MEMORANDUM

TO: William A. Jones, P.E., Linden Engineering
FROM: Jessica Wala, Nitsch Engineering
DATE: March 31, 2022
RE: New Swampscott Elementary School
Peer Review
Response to Comments

The following responses and supporting documentation are in response to peer review comments received on March 28, 2022 from Linden Engineering Partners, LLC, in response to the Notice of Intent submission dated February 23, 2022.

Profile Plot: Detention System #2 to 18-inch Ex. Pipe

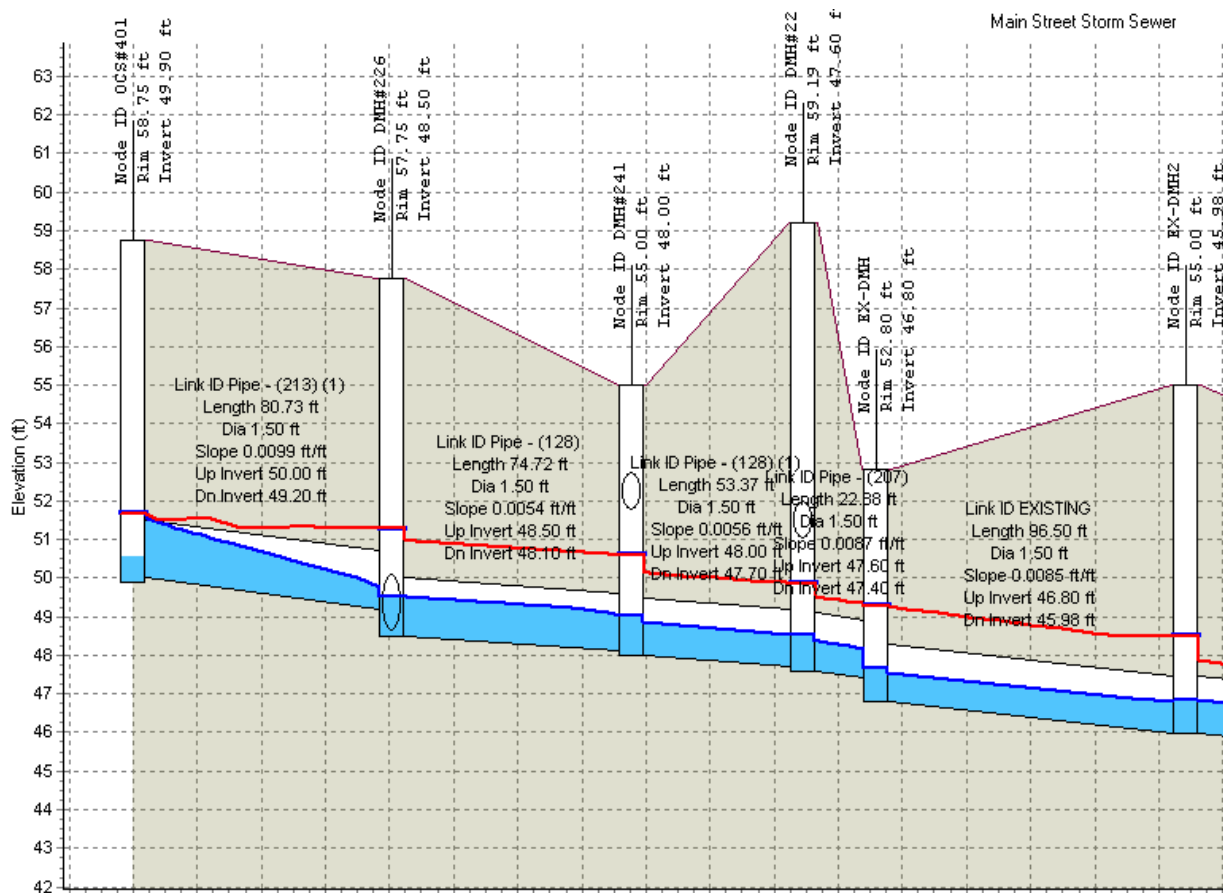
See the below profile plot of the pipe run from Detention System #1 (OCS #400), which indicates that though the existing 18-inch pipe is surcharged, the hydraulic grade line does pass above the bottom of the detention system structure/outlet structure, therefore is not surcharging/flooding the system and the detention system will be able to freely drain. Maximum HGL is shown in red.

Detention System #2: Nitsch Engineering revised the elevations of Detention System #2 and upstream pipe elevations to raise the detention system above the maximum hydraulic grade line, based on the SSA analysis incorporating the existing 18-inch pipe.

See below profile plot of the pipe run from Detention System #2 (OCS #401), which indicates that the maximum HGL elevation is 51.7. As a result of this updated SSA Analysis (incorporating the existing 18-inch drain pipe), Nitsch Engineering raised the elevation of Subsurface Detention System #2 so that the bottom of the stone elevation is 51.50, top of stone elevation is 55.00. Nitsch revised the upstream pipes to accommodate the higher detention system elevation and ran the SSA analysis to confirm that the upstream drainage network will not be surcharged. As a result, even during conditions when the downstream pipes are surcharged during peak flow events due to the limited capacity of the existing 18-inch pipe, the subsurface detention system will not be surcharged and there will be no flooding at the detention system/upstream structures.
